Memorandum

Whangarei Level 1 BDO Business Centre 15 Porowini Avenue Morningside Whangarei 0110 +649 358 2526		Auckland PO Box 91250 Auckland 1142 +649 358 2526		Hamilton PO Box 1094 Hamilton 3240 +647 960 0006		Tauranga PO Box 13373 Tauranga 3141 +647 571 5511	Wellington PO Box 11340 Wellington 6142 +644 385 9315
	Nelson 27 Vanguard Street Nelson 7010 +643 548 8551		Christchurch PO Box 110 Christchurch 8140 +643 366 8891	\boxtimes	Queenstown Level 1 72 Shotover Street Queenstown 9300 PO Box 1028 Queenstown 9348 +643 441 1670		Dunedin 49 Water Street Dunedin 9016 +643 470 0460	
At	tention:	Liz	White					
Co	ompany:	on	behalf of Timaru Di	strict	Council			
Da	ate:	08/	10/2024					
From:		Yvonne Pfluger, Partner, Landscape Planner						
Message Ref:		Response to Submissions on Natural Character and Natural Features & Landscapes Chapters						
Proiect No:		BM240365

In 2024 BML were asked to provide input into the s42A Report relating to submissions on the Natural Features and Landscapes Chapter and the Natural Character Chapter of the Proposed District Plan (PD). The responses to the submissions BML were asked to provide input into are outlined in this memorandum. The findings in thi

Figure 1

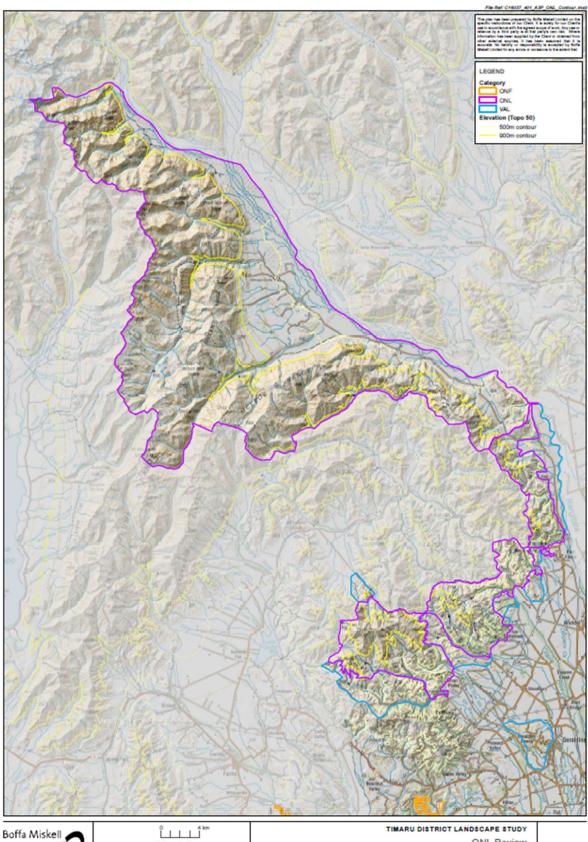
Based on a review of the location of the 500m contour line, it appears to align reasonably well with the base of the hills in the Upper Rangitata catchment ONL. Around the front ranges the 500m contour extends in general around the tops of the eastern spurs. The 900m contour falls generally onto the base of the more steeply rising slopes in the upper Rangitata catchment and relatively close to the tops of the Four Peaks Range (eg Little Mt Peel 1113masl). In the mid Rangitata area (upstream of the gorge) the area between 500-900masl includes the large open fans that are slightly elevated above the valley floor, as well as the valley floor itself along the Rangitata Gorge section. Figure 1 (see last page) shows the extent of ONFLs and VALs in relation to both the 500 and 900m contour lines.

I consider that the slopes located between the 500-900m contours are visually sensitive to change, in particular along the Four Peaks Range, where they form the prominent backdrop to the plains. In this area I consider that the application of this standard would be more meaningful if it was linked to the 500m contours where it would help to protect the slopes and spurs of ONLs from landscape and visual effects associated with the placement of buildings, structures and irrigators. In my view, it would be appropriate to require resource consent for buildings on these slopes.

In the Upper Rangitata ONL, I consider the elevated fans to be of an intermediate sensitivity, compared to the more modified valley floor on the eastern side of the Rangitata Gorge Road and the highly natural slopes of the MacLeod, Sinclair and Two Thumb Ranges to the west. While buildings and structures are likely to be appropriate in some locations between 500-900masl, a consent requirement would ensure that they are sensitively located within this area.

I have considered the other standards applying to built form in ONLs and do not consider that in combination that they are sufficient to adequately protect these landscapes. I therefore, support the submitter's request in relation to buildings in ONLs between 500-900masl.
